APPEAL SUMMARY

Status: Decision Rendered**Appeal ID:** 15818**Project Address:** 921 NW 21st Ave**Hearing Date:** 9/13/17**Appellant Name:** Joe Zody**Case No.:** B-007**Appellant Phone:** 503-327-0322**Appeal Type:** Building**Plans Examiner/Inspector:** Geoffrey Harker, John Butler**Project Type:** commercial**Stories:** 4 **Occupancy:** R-2, A-2, S-2 **Construction Type:** V-A**Building/Business Name:** 21 Astor**Fire Sprinklers:** Yes - Full Coverage**Appeal Involves:** Erection of a new structure**LUR or Permit Application No.:** 16-102461-CO**Plan Submitted Option:** pdf [File 1] [File 2] [File 3]**Proposed use:** Mixed Use / Multi Family

Continuity of exterior fire rated walls at intersecting floor ceiling assemblies: Granted as proposed.

FIRST FLOOR
PLAN

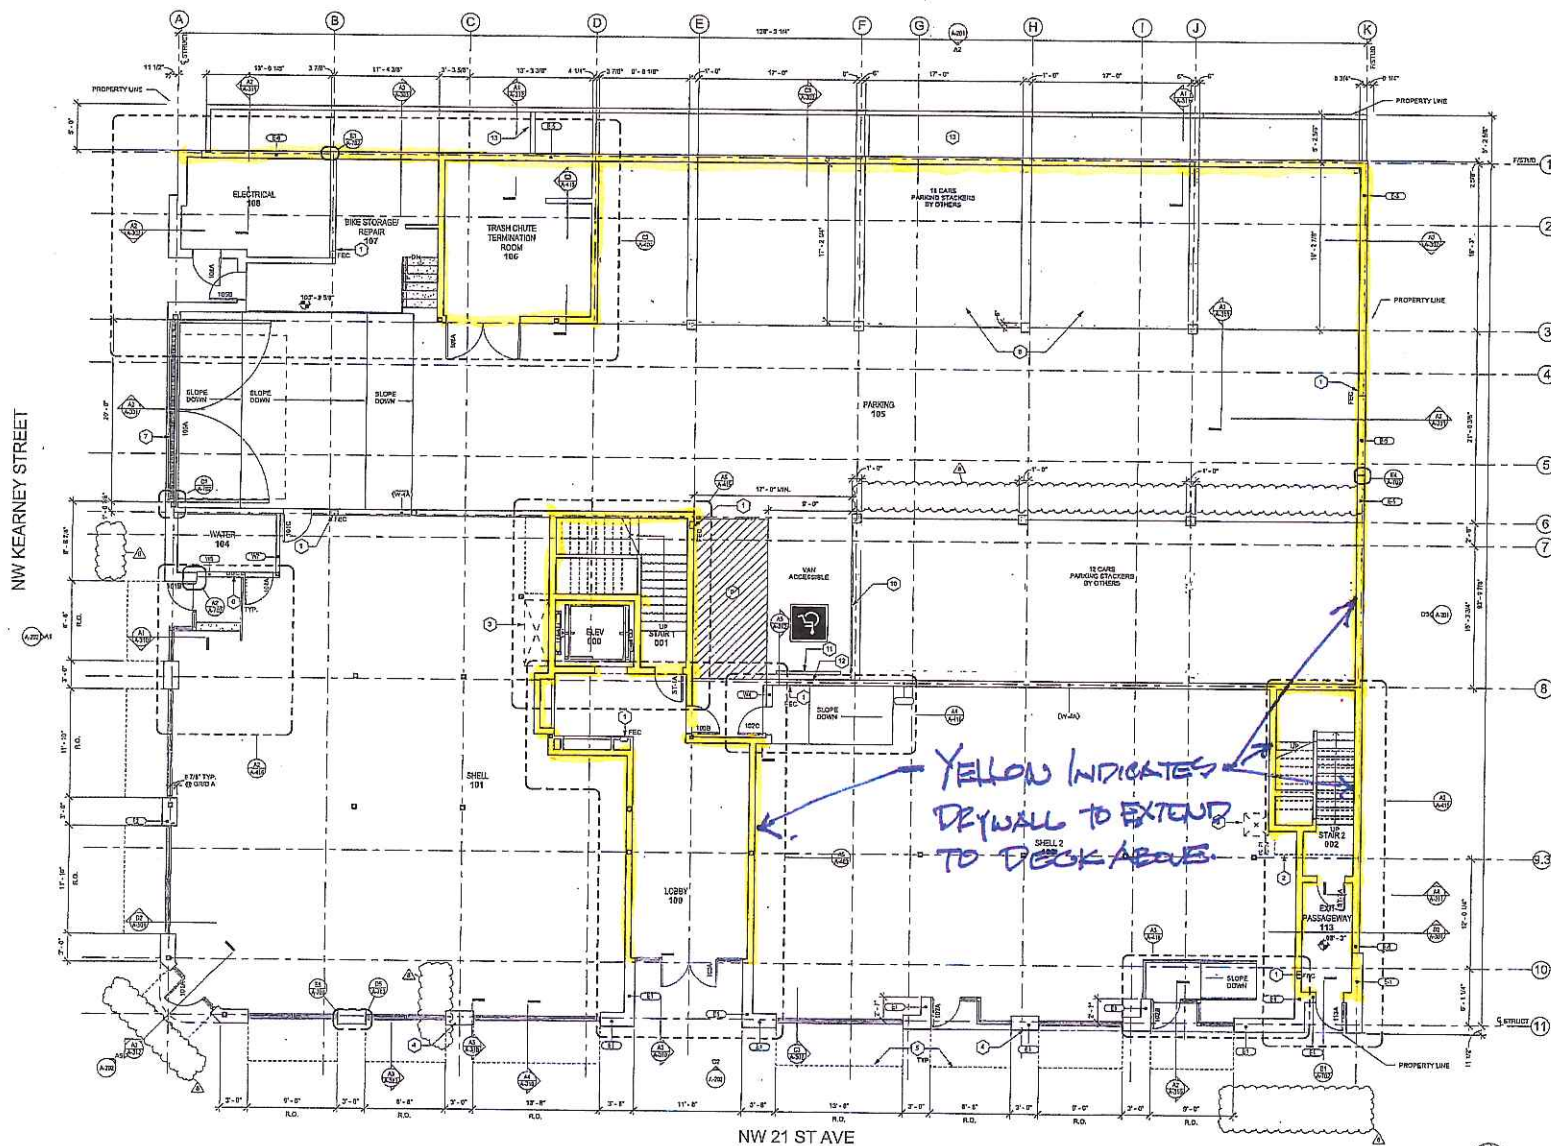
We contend that our current design for the exterior wall, framing, and floor system meets the Type V-A, one-hour fire rating required by the code. This appeal is specifically speaking to the exterior walls along gridline A, 11, 4.2, and E between 2 and 4.2. All of these walls have a Fire Separation Distance greater than 30' and allow unlimited and unprotected openings. The building is fully sprinkled and has a fully addressable alarm system.

Floor plans showing the first floor and typical upper floor that indicate the grid lines associated with the exterior walls in question.

Exterior Walls – Intersecting Floors

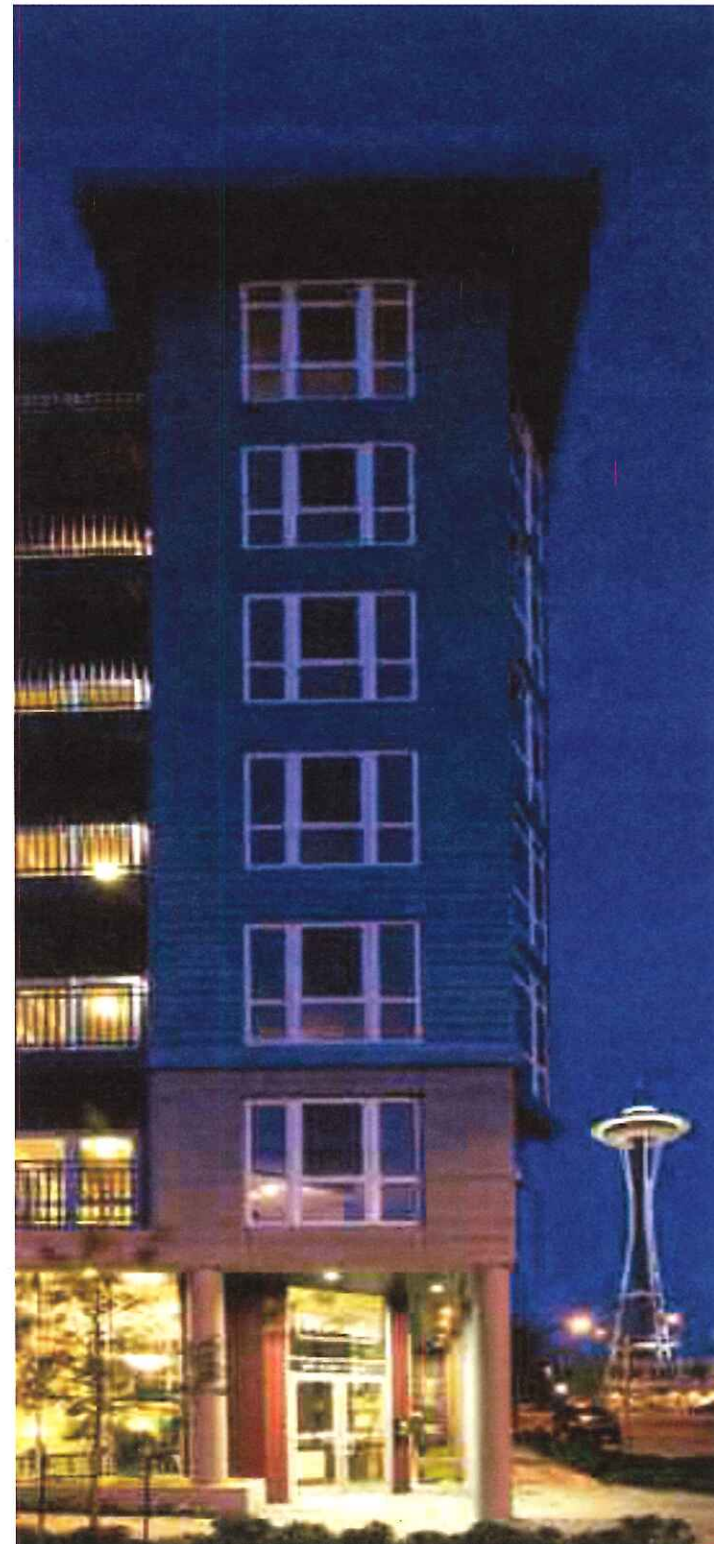
Alternate Example: We have included an excerpt of a detail provided by WoodWorks Wood Product Council that shows an accepted practice for a Type III typical 5 over 1 building. This clearly shows that the wall membrane stops at the rated ceiling system as an accepted practice in a building type that is a more restrictive rating than the proposed building.
